New Albany Planning Commission
January 19, 2022 Minutes

FPL-132-2021 Final Plat

VAR-133-2021 Variance

FDP-1-2022 Final Development Plan

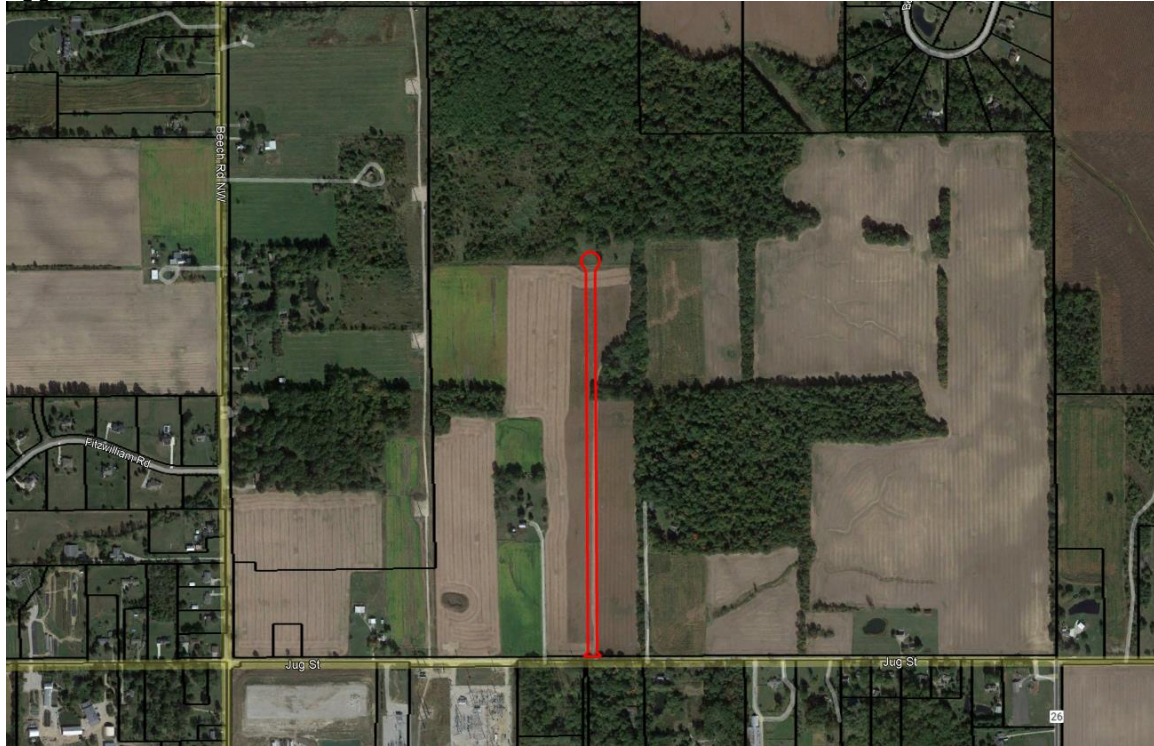
1. Provide more information on the plat regarding cross access easements that will accommodate emergency responders.
2. Obtain approval from the City of Columbus for the proposed 10' water line easement. Ensure that the easement is wide enough to maintain a minimum 7.5' offset from the water main and right-of-way and 20' offset from all building structures.

3. In accordance with code section 1187.06 (a)(2) show the angle and distance to the nearest street intersection.
4. Provide more information on the plat regarding the provision of utility easements to accommodate private utility providers (e.g., gas, telecom, electric, etc.).

5. In accordance with code sections 1187.06 (c)(1) and (2), provide written documentation indicating that Ohio EPA and Army Corps of Engineers permitting issues have been addressed.

6. Refer to Exhibit A. Reformat the plat in accordance with this exhibit including adding Horizon Court to the title block.
7. Show drainage easements on the plat associated with the regional basin. Provide the City's standard drainage easement note block on sheet 1 of the plat.

8. Label the instrument number for all existing easements shown on the plat.

1. The variance application (VAR-133-2021) associated with this new roadway must be approved.
2. The city engineer comments must be addressed, subject to staff approval.

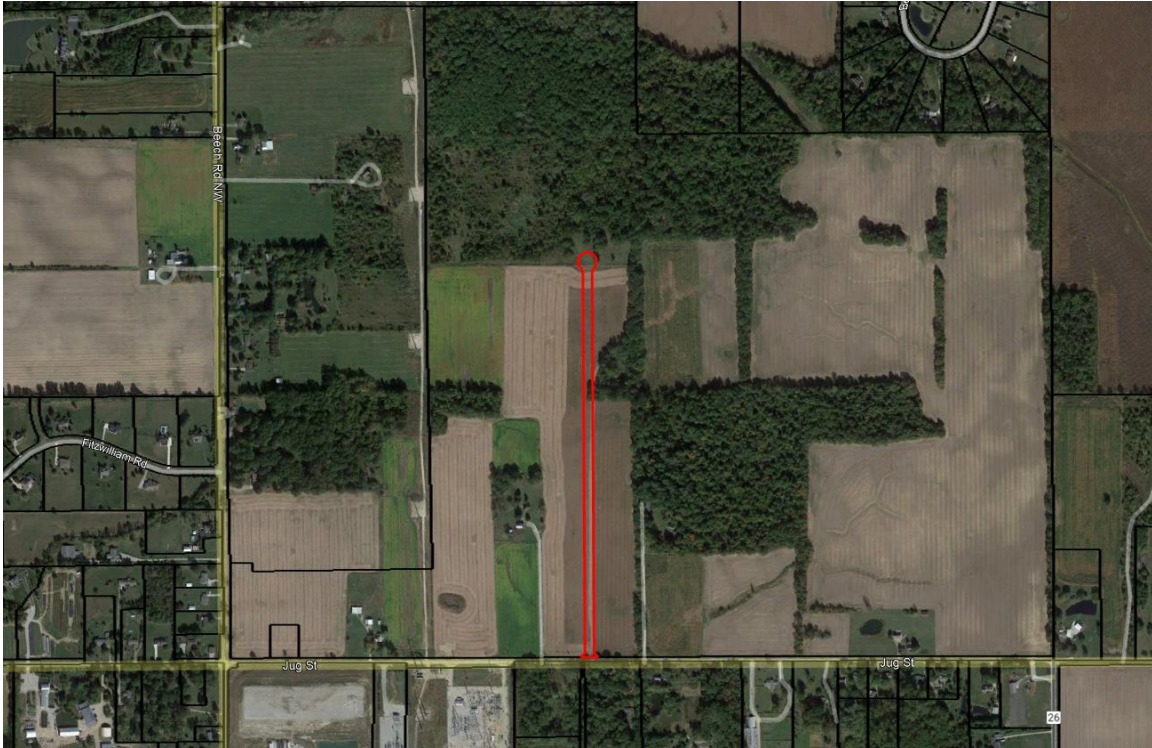
4. The city traffic engineer has reviewed the application (see comments below) and states that even though the proposed cul-de-sac is longer than what is permitted, the applicant is meeting the spirit and intent of requirement based on the conceptual site/internal roadway plan by providing multiple roadway connections via shared and connected private drives in order to both minimize traffic congestion and provide sufficient access for emergency responders.

- b. The TIS assumed most development traffic was routed through the Jug/Beech intersection, and the rest to the east towards Clover Valley Road. A cursory review of the results indicates that even if all site traffic were routed through the Jug/Beech intersection, the conclusions would still not change.

- c. The review recommended the Jug Street frontage be improved to meet typical City standards (such as shoulder/ditch improvements).
2. A 2,600-ft cul-de-sac is proposed for this development as a main access and designed as a public street. A second access (private) along the east frontage appears to provide a continuous alignment to the north that curves near the north end of the property and intersects with the cul-de-sac. An access drive is also proposed along the west side of the site but is not continuous. The result is the development plan shows an alternative route to/from the end of the cul-de-sac.

1. This is a critical item for cul-de-sac design for any development, to ensure emergency response times are minimized. For extended cul-de-sac lengths, providing an alternative access becomes a critical factor for ensuring public safety.
2. For the development plan, the access along the east frontage appears to be continuous and could provide an alternative emergency response route. The applicant notes that cross access easements between parcels will be provided. It is recommended cross access easements be required as part of the development approval.
3. It is recommended the applicant confirm that the east access driveway can serve as an unimpeded alternative route for emergency response.

Staff recommends approval of the variance request. This cul-de-sac street will be designed to primarily accommodate truck traffic and minimize the truck traffic throughout the rest of the campus. While the city strategic plan discourages cul-de-sacs, this proposal appears reasonable given the proposed development pattern and interconnectivity between sites and multiple public streets.
